March 28, 2018

MAS Comments on the 80 Flatbush Avenue Rezoning Proposal, CEQR No. 17ECF001K, Brooklyn, NY

Figure 1 - Proposed Development at 80 Flatbush; Southwest view showing Fort Greene Park in the foreground

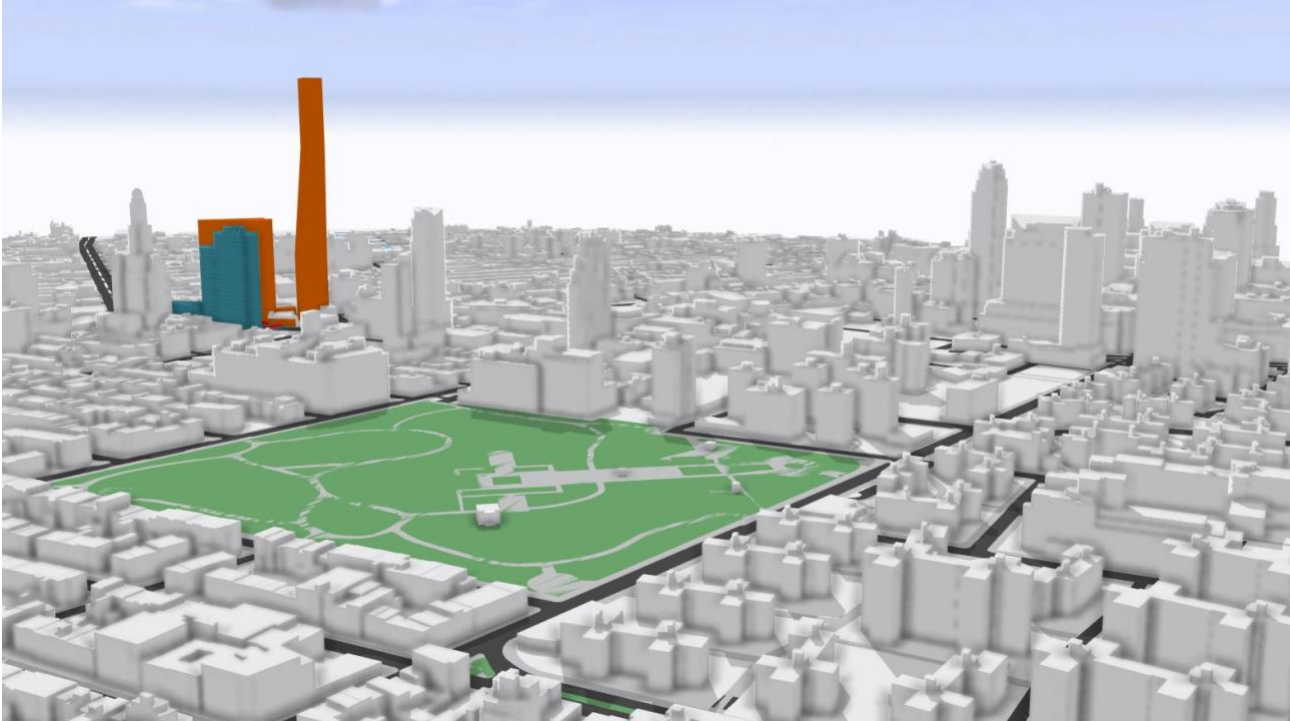
The magnitude of the proposal cannot be understated (Figure 1). With an FAR of 18, it would represent the highest density development outside of Manhattan since 1961 that does not use a transfer of development rights to achieve its peak density.

Figure 2 – 2014 view of shadows near Rockwell Place Bears Community Garden at 10am in September

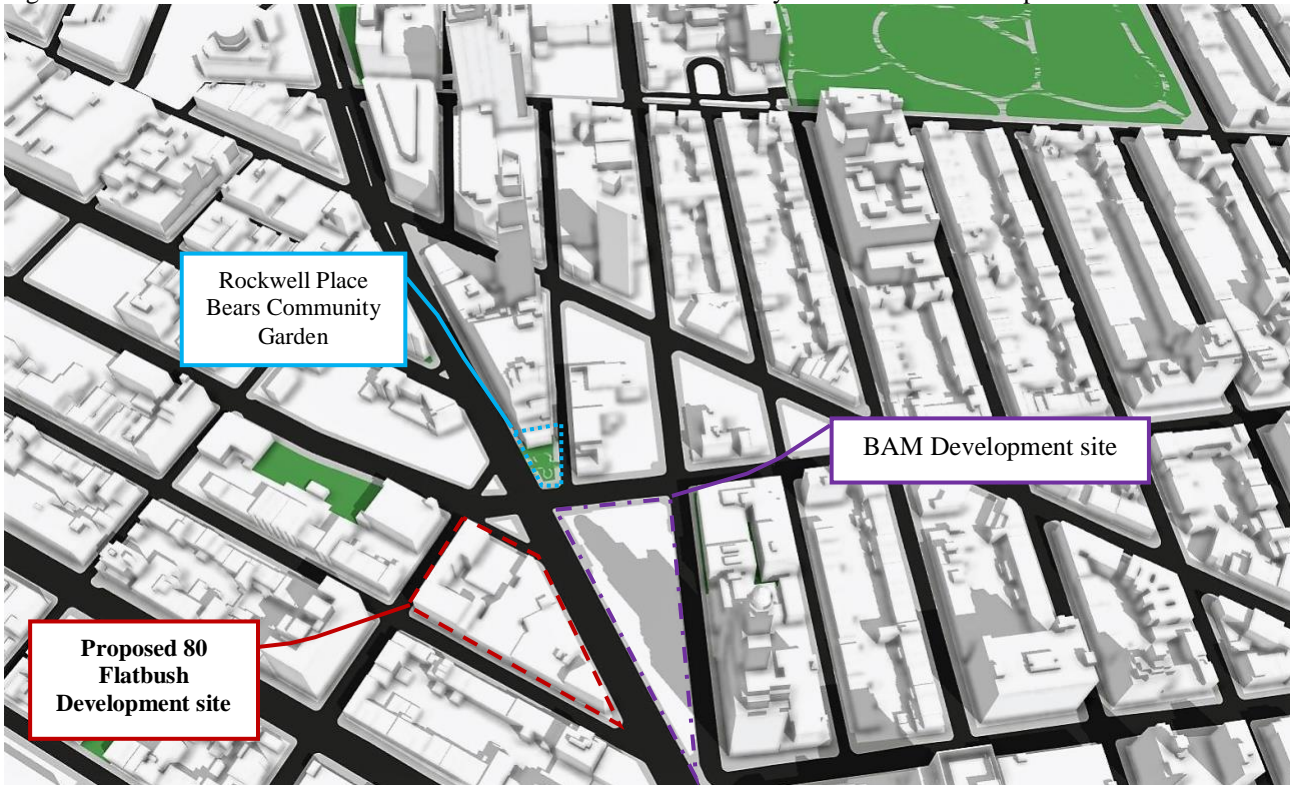
Following the Downtown Brooklyn Rezoning and subsequent redevelopment of the Brooklyn Academy of Music (BAM site) at 300 Ashland Place, the area has seen a continual erosion of the amount of sunlight that reaches the limited public open space. This raises serious concerns about unaddressed cumulative impacts of the proposed development (Figure 2).

Figure 3 – BAM development shadows on Rockwell Place Bears Community Garden at 10am in September.

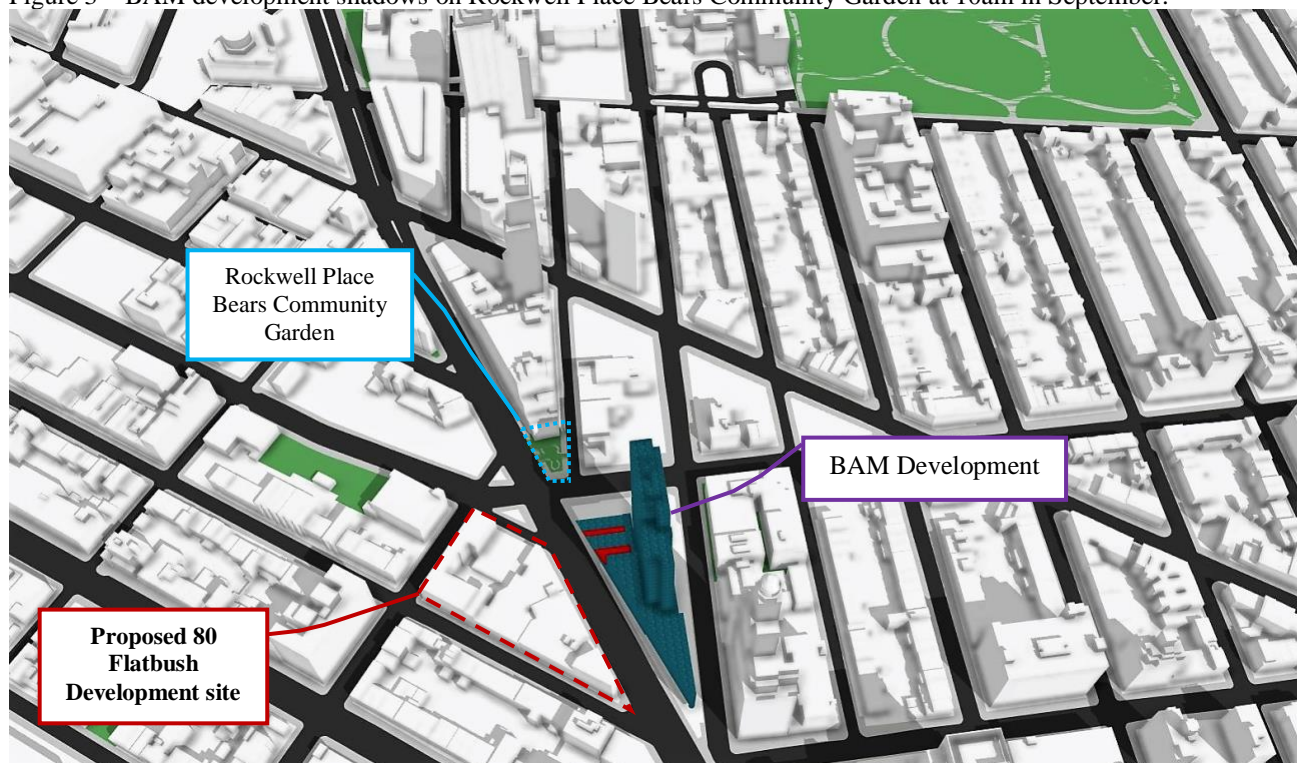
A 2012 Technical Memorandum issued for the BAM site redevelopment evaluated shadows on RPBCG.⁸ While the memorandum acknowledged that incremental shadows would be generated during the morning hours for three out of four evaluation time periods, it concluded that no adverse shadow impacts would occur (Figure 3).
